# Review of a Report Providing Health Impact Assessment and Cost-Benefit Analysis (CBA) of Eskom activities

Dr Michael Holland, [mike.holland@emrc.co.uk](mailto:mike.holland@emrc.co.uk), Dr Joseph Spadaro  
14<sup>th</sup> February 2019

*The provision of professional, independent consulting services to assist Eskom in compiling applications for renewed postponement of the Minimum Emission Standards: Component 4: Health impact focused cost benefit analyses, Deliverable 2: Final Report (Version 7.4) 26 November 2018*

**Figure 21 Sensitivity analysis of the effect of pollution concentration intervals on predicted mortality incidence.**

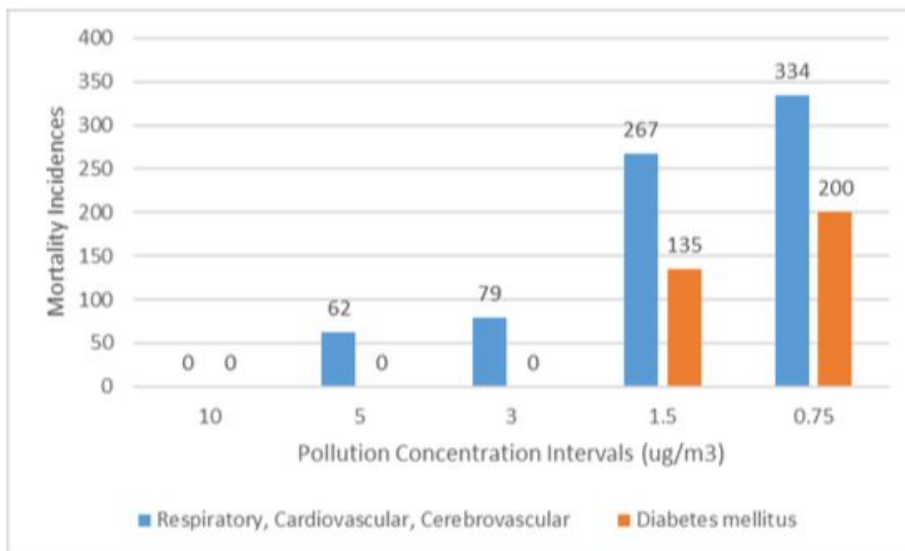
We note that some elements of the calculations presented are wrong: 4.17 million multiplied by 0.0413% = 1,722 deaths, not 2,792 as stated.

The method shows a fundamental misunderstanding of the derivation and application of the response functions derived from epidemiological data. The specification of functions requires information on three parameters:

The effect of using an interval is simply to remove some part of the exposure from analysis. By doing so, the estimate of damage will be artificially reduced. We are unaware of anyone else carrying out the exposure assessment in this way.

The sensitivity analysis shown in Figure 21 of the Eskom report demonstrates the errors arising from treating response functions as non-continuous, referring to a series of discrete intervals. Taking a  $10 \mu\text{g}\cdot\text{m}^{-3}$  step in concentration, no effect of power station emissions is observed: in other words, the modelling does not show power stations generating more than  $10 \mu\text{g}\cdot\text{m}^{-3}$  across the modelled domain and so there is no exposure above  $10 \mu\text{g}\cdot\text{m}^{-3}$  to model for effect. Effects start to emerge when the interval is reduced to  $5 \mu\text{g}\cdot\text{m}^{-3}$  and continue to increase as the increment in concentration is reduced. The smaller the interval, the bigger the estimate of damage. This variation is simply an artefact of the modelling approach. Response functions should be applied directly to modelled concentrations for each municipality: there is no need to define “*at what interval the ERFs would result in significant differences in health outcome incidences*”.

The Eskom report uses an interval of  $0.2 \mu\text{g}\cdot\text{m}^{-3}$ , lower than the  $0.75 \mu\text{g}\cdot\text{m}^{-3}$  interval that is the smallest shown in Figure 21. It follows then, that the estimated mortality that is fed through to the CBA is higher than shown in the figure, but the report provides no data. Halving the interval from  $1.5 \mu\text{g}\cdot\text{m}^{-3}$  to  $0.75 \mu\text{g}\cdot\text{m}^{-3}$  increases the impact of exposure to  $\text{PM}_{2.5}$  by 48% (refer to the figures shown for diabetes, where impact increases from 135 deaths to 200 deaths). Without re-running the analysis, it is not possible to say by how much estimates should be increased with any certainty. Assuming that figures with no interval (i.e. moving from an interval of  $0.75 \mu\text{g}\cdot\text{m}^{-3}$  to  $0 \mu\text{g}\cdot\text{m}^{-3}$ ) should increase by a similar amount (48%) to that arising when moving from an interval of  $1.5 \mu\text{g}\cdot\text{m}^{-3}$  to  $0.75 \mu\text{g}\cdot\text{m}^{-3}$  would increase the estimate of the total number of deaths calculated in the previous section as attributable annually to the 13 power stations from 1,250 to 1,850. These combined changes, taking estimates from an original 534 cases per year to 1,850, lead to significant convergence with the estimate of 2,200 deaths calculated previously by Myllyvirta (2014).

**Conclusion: The approach taken for linking pollutant concentrations with response functions is claimed by the authors to be conservative, leading to higher estimates of the number of deaths from various causes than might otherwise be calculated. It is concluded here, however, that this is not the case. The interval-based approach used in the Eskom report, however, has the effect of removing some part of exposure from the calculations, and hence is inherently non-conservative leading to underestimation of impacts. The degree of underestimation is unknown but could be up to 50%. This is additional to other biases to underestimation identified above.**
